Project	IEEE 802.16 Broadband Wireless Access Working Group < http://ieee802.org/16 >	
Title	Enhanced piggyback request scheme	
Date Submitted	2008-01-15	
Source(s)	Okseon Lee Jonghyung Kwun Geunhwi Lim Yeongmoon Son Samsung Electronics #416, Maetan-3dong, Yeongtong-gu Suwon-city, South Korea	Voice: +82-31-279-5219 E-mail: okseon.lee@samsungcom
Re:	IEEE Working Group 802.16 Letter Ballot #26 as announced in IEEE 802.16-07/049	
Abstract	This contribution proposes multiple piggyback requests for CIDs in a SS using extended subheader.	
Purpose	Adopt the proposed change in IEEE802.16REV2/D2	
Notice	<i>This document does not represent the agreed views of the IEEE 802.16 Working Group or any of its subgroups. It represents only the views of the participants listed in the "Source(s)" field above. It is offered as a basis for discussion. It is not binding on the contributor(s), who reserve(s) the right to add, amend or withdraw material contained herein.</i>

Enhanced piggyback request scheme

2. Proposed text change

[Figure 38 – A case for e-PBR extended subheader](#)

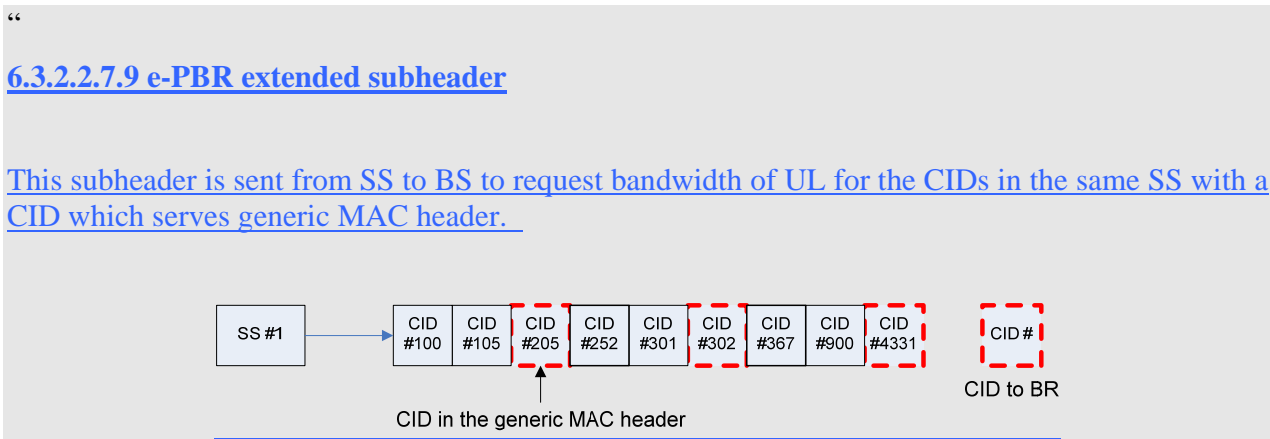
[Insert new part in the section 6.3 of IEEE802.16REV2/D2, as follows]

[This subheader can be used when the CID of generic MAC header is sending packets in uplink and the other CIDs in the same SS need BR. Set the ESF field to 1 in the generic MAC header and an extended subheader for e-PBR can be attached.](#)

BS already knows all CIDs of each SS, so the same CID list can be made per SS in BS and SS with predetermined role such as ascending order. The SS can indicate the order of CID to BR from the CID list instead of CID itself. In the figure 38, CID number 302 want BR and the order of CID is 6 in the list, so PBR CID index is 6. If the BS receives this e-PBR extended subheader, the BS can know which CID of the SS want BR with combination of generic MAC header CID and the order of CID from the CID list.

For the case of the figure 38, the value of the number of PBR field is 3 and the followed Piggyback Request field is for the CID in the generic MAC header – CID 205. And first PBR CID index is attached with value of 6 and the followed Piggyback Request field is for CID 302. And second PBR CID index is attached with value of 9 and the followed Piggyback Request field is for CID 4331.
